BCA Assessment Report

Julius Avenue Data Centre Project
6-8 Julius Avenue, North Ryde

Revision 4
16 December 2025
Reference: 240434

Figure 2 – Typical Fire Compartment configurations

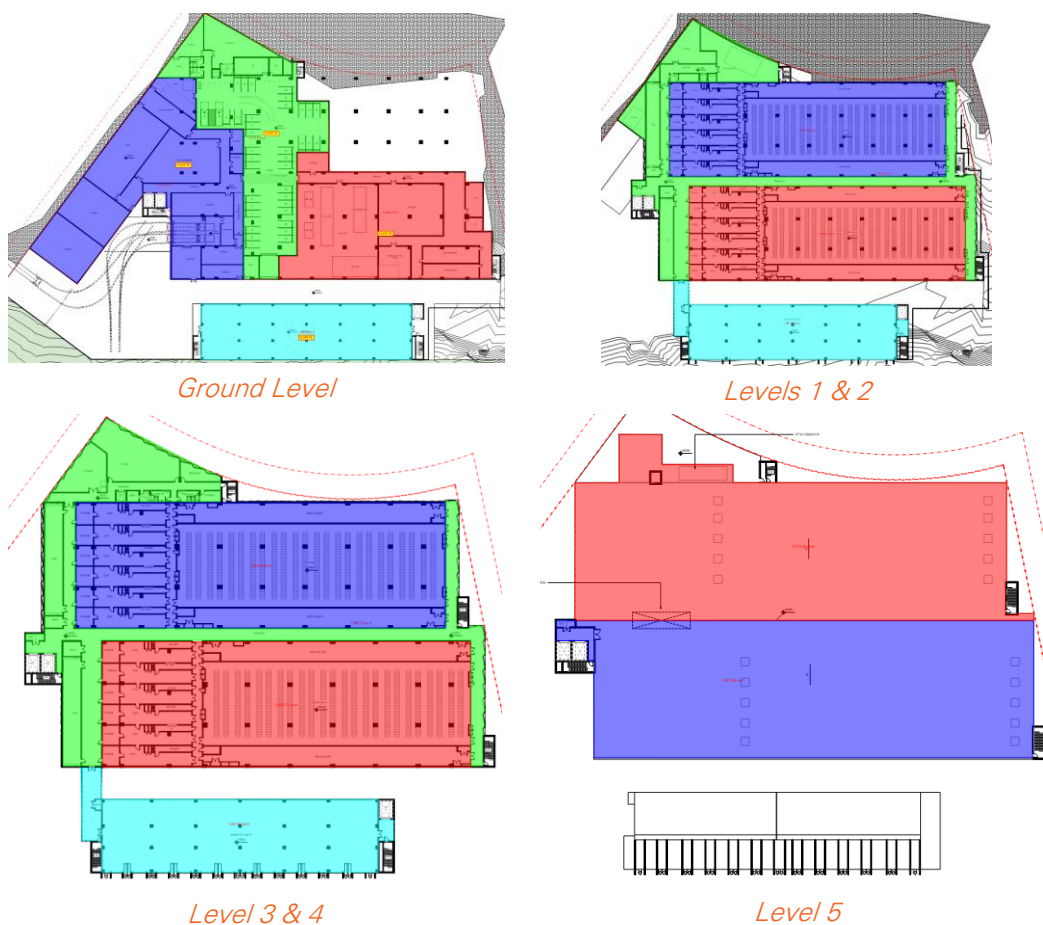
Comment: It is noted that the proposed Data Centre is to be divided into multiple fire compartments on each level of the building, as noted in the examples of the typical levels below. Confirmation of the floor area and volume of each of the proposed fire compartments shown indicatively in Figure 2 below are to be provided by the Architect at the CC Application stage to confirm compliance with Table C3D3, however, it is noted that compliance is readily achievable.

Figure 3 – Protection of Openings between Fire Compartment – Levels 1-4

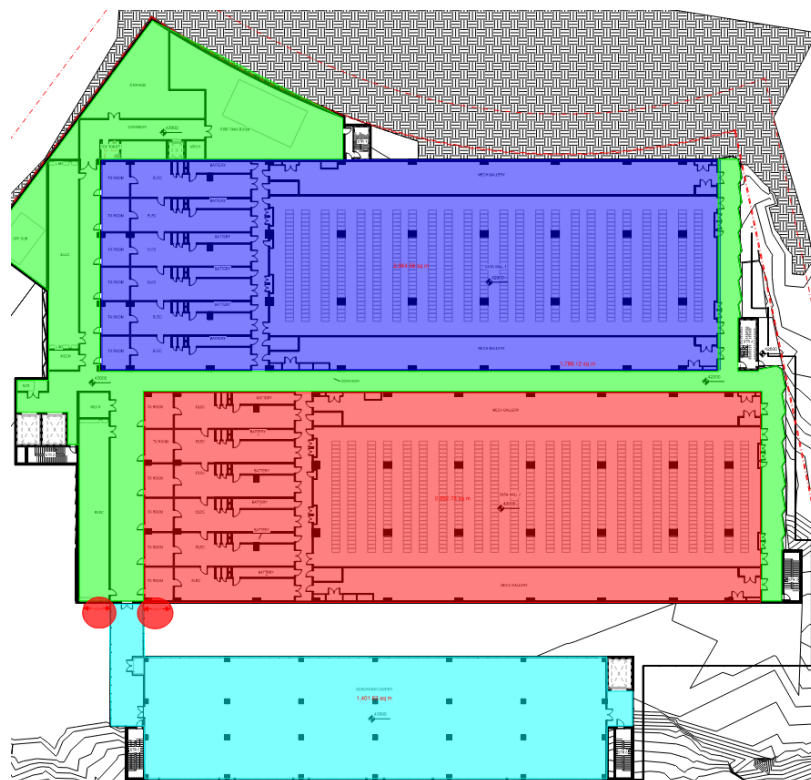
Comment: Throughout Levels 1-4 of the building there are two instances of exposure between separate fire compartments, at the link bridge structure to the generator gantry. The locations where protection is required in accordance with C4D4 are circled in red in Figure 3 below. A Performance Solution from the Fire Engineer may be considered to address these requirements in the locations identified below.

Figure 4 – Walls requiring protection as per D2D12

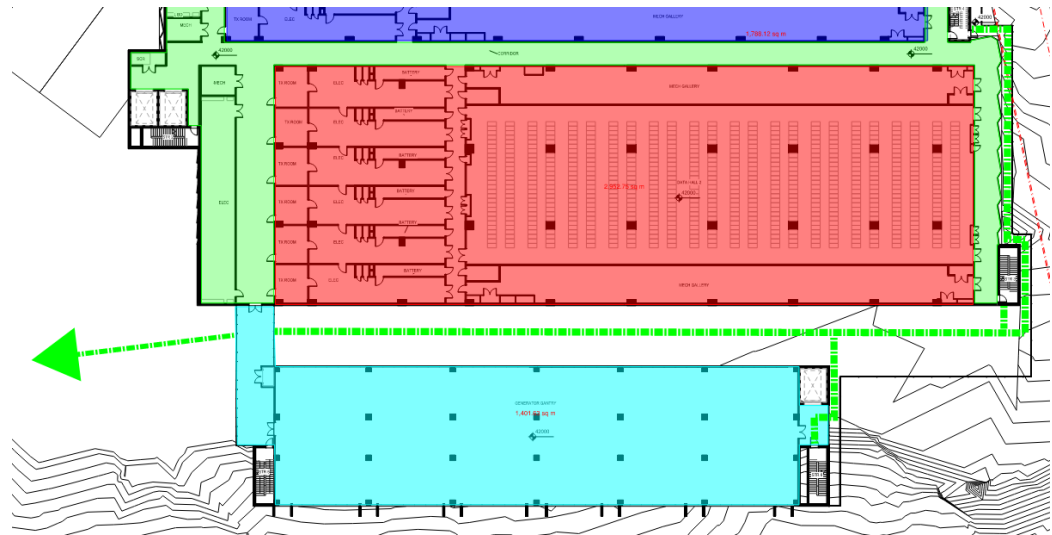
Comment: A Fire Engineered performance solution is likely be required to allow the fire stairs on the eastern and western ends of the generator gantry levels to discharge inside the building. Further details of the discharge path are to be provided to confirm whether compliance with D2D12(b) or (c) is achievable.

Details of compliance with the protection of discharge path requirements of D2D12(3) for each fire stair are to be provided on the FRL plans to be submitted with the CC Application – see Figure 4 below that identifies the fire stair discharge paths and their proximity to the external walls of the building.

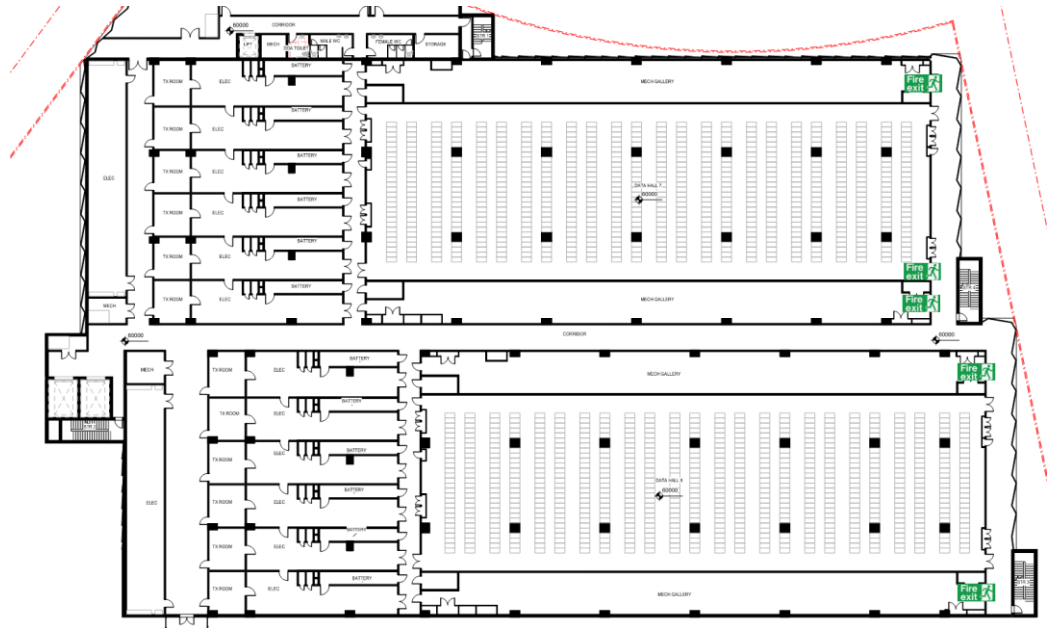
Comments: All exit discharge points from the buildings are required to be protected in accordance with the requirements of this clause. In addition, details of the grades and any stairs to the discharge pathway from the exits on the southern side of the building along the new Access Road to Julius Ave are to be provided for review to confirm compliance with D2D15(3).

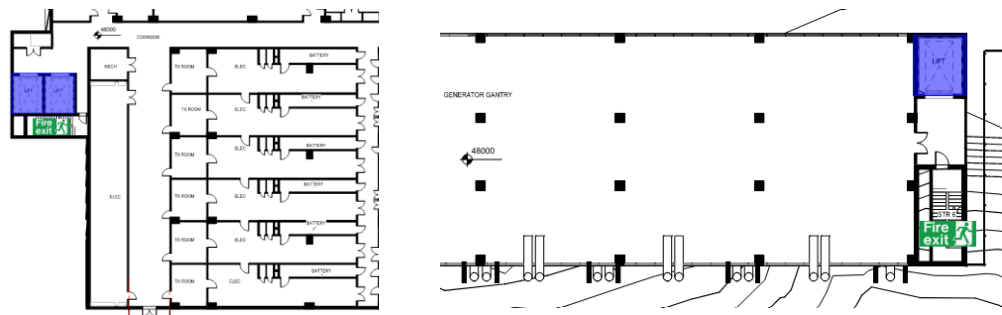
Comment: It is noted that Lithium-Ion batteries (or equivalent) are proposed to be stored/utilised within Battery Rooms adjacent to the Data Halls in significant quantities on all levels. Details will be required from both the mechanical system designer and the fire engineer confirming that the proposed smoke hazard management systems have the required capability to address the additional hazard resulting from the Lithium-ion battery storage in the building. Details of the proposed additional smoke hazard management systems are required to address the additional hazard resulting from the proposed storage or use of the building.
E3D4	Warning Against use of Lifts in Fire: Warning signs required be provided must be displayed where they can be readily seen and must comply with the details and dimensions of Figure E3D4. Comment: Lift Contractor to note.
E3D5	Emergency Lifts: An emergency lift must be installed in: + A building exceeds 25m in effective height; and + A class 9a building which has patient care areas located on a level that does not have direct egress to a road or open space. The emergency lifts must be contained within their own fire resisting shaft; must serve all levels served by passenger lifts. Where two or more passenger lifts are installed at least two emergency lifts must be provided to serve those storeys served by the passenger lifts and where the passenger lifts are in separate shafts, at least one emergency lift must be installed in each shaft. Comment: The building exceeds 25m in height and thus requires emergency lifts. Details to be provided prior to CC application, where emergency lifts must be provided in the sperate shafts highlighted in blue below. See Figure 6 below for details of the locations of the required emergency lifts – compliance is readily achievable.  <i>Figure 6 – Emergency Lift locations</i>
